Notice of Alteration Form

Client File No. : 4412		Environment Act Licence No. : 2482R	
Legal name of the Licencee: Rural Municipality of Ritchot			
Name of the development: Ritchot Class 1 Waste Disposal Ground			
Category and Type of development per Classes of Development Regulation: Waste Treatment and Storage                                      Class 1 Waste Disposal Grounds			
Licencee Contact Person: Mr. Steve McCabe, MidCanada Environmental Services			
Mailing address of the Licencee: 1090 Kenaston Blvd.			
City: Winnipeg		Province: MB	Postal Code: R3P 0R7
Phone Number: (204)987-9600      Fax: (204)987-9601      Email: smccabe@gfenv.com			
Name of proponent contact person for purposes of the environmental assessment (e.g. consultant): David Ediger, D. Ediger Consulting Services			
Phone: (204)771-4245		Mailing address: 296 Baltimore Road, Wpg, R3L 1J1	
Fax:			
Email address: dedigerconsulting@mymts.net			
Description of Alteration ( <i>max 90 characters</i> ): Removal of centre berm within landfill and increase in finished height to 12 metres

Notice of Alteration – R.M. of Ritchot Waste Disposal Ground,  
Environment Act Licence No. 2482R

FIGURE NO: FIGURE 5

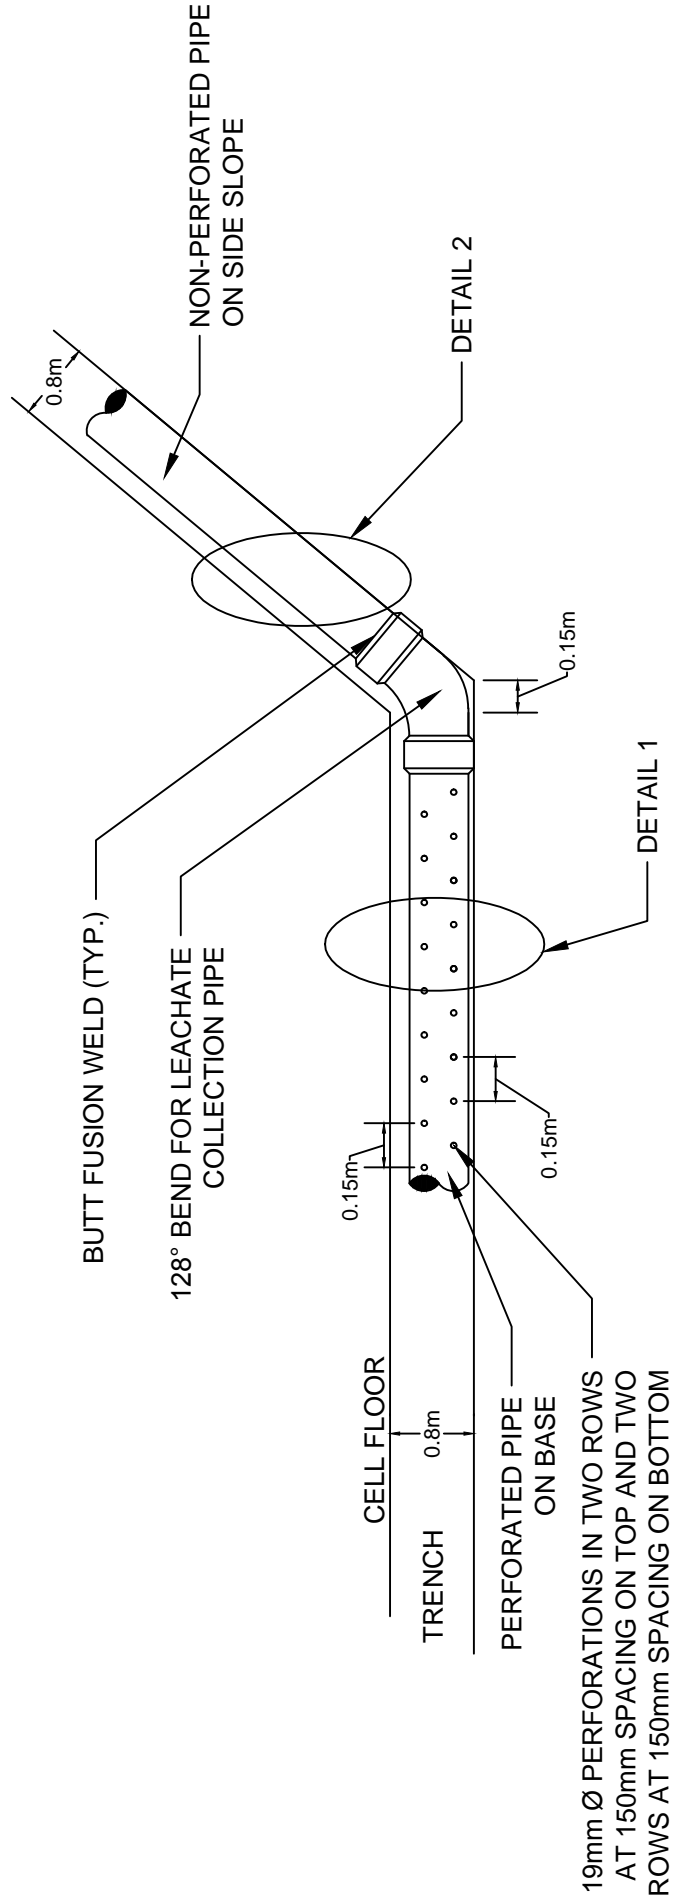
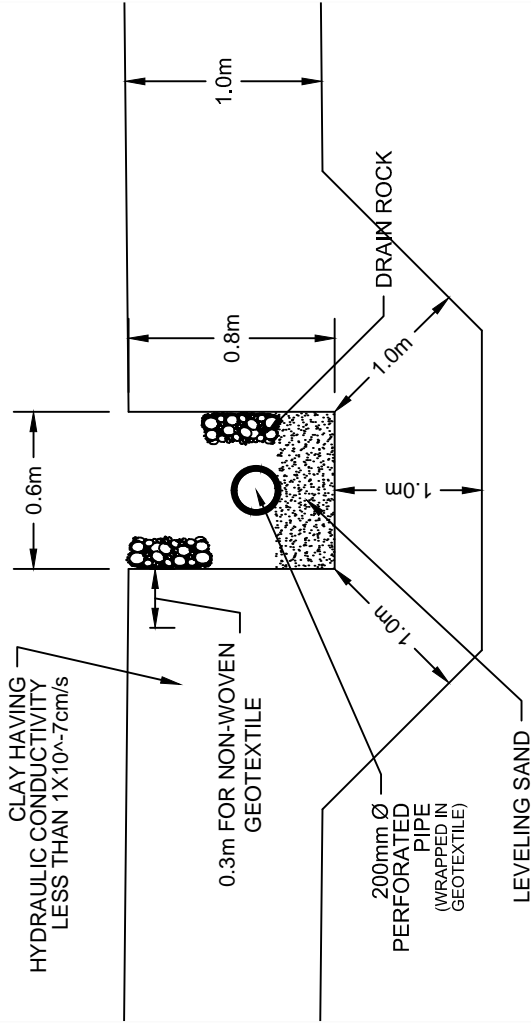
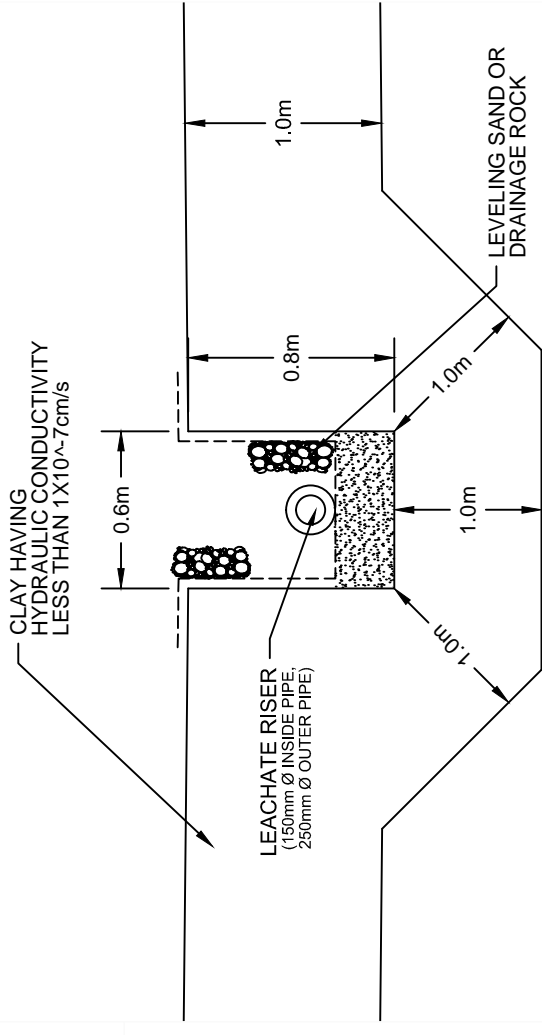
The leachate collection system will remain essentially the same as in the original proposal. Details of the leachate trench and collection system are shown in AMEC Figures 4 and 5. All leachate risers will be constructed up the east slope of the respective cells.
